## PRELIMINARY BCA ASSESSMENT REPORT

<b>To:</b>	Goodman		
<b>Attention:</b>	Richard Seddon	<b>Date:</b>	11/9/2008
<b>From:</b>	Tony Heaslip	<b>Sent by:</b>	Email
<b>Project:</b>	ARCBS – 17 O’Riordan St Green Square	<b>Project No:</b>	80313
<b>Copies:</b>	Goodman – Adrian Tesoriero	<b>Pages:</b>	11

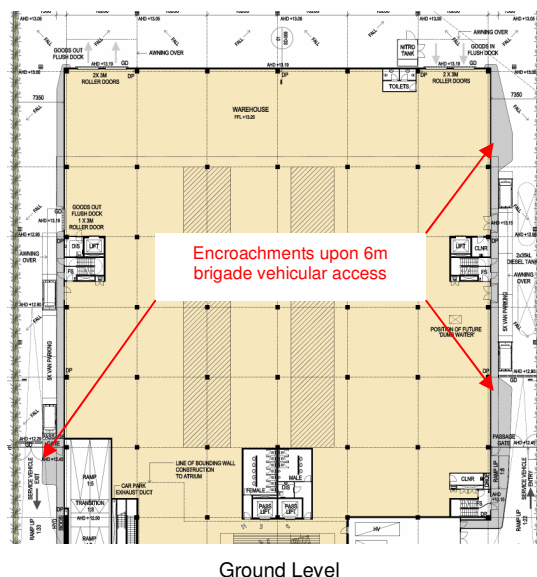
The referenced plans generally show compliance with the above, however there is a relatively minor non-compliance on the northern and southern sides where the kerb/footpath encroaches upon the required 6m vehicular access as indicated below.

We note that a fire engineered Alternative Solution will be prepared by Rawfire to address this DTS non-compliance in consultation with the NSW Fire Brigades. It is understood that the fire engineered Alternative Solution will effectively demonstrate that the current proposal satisfies BCA Performance Requirement CP9 with no additional measures being required.

The Alternative Solution will be referred to the NSW Fire Brigades prior to issue of the CC in accordance with clause 144 of the EP&A Regulation 2000. In the unlikely event that the brigades do not support this Alternative Solution then the footpaths/kerbs will need to be recessed to ensure that a minimum 6m width is achieved. In this instance, it is considered that a change of this nature could be addressed at CC stage without giving rise to any inconsistencies with the Development Consent.
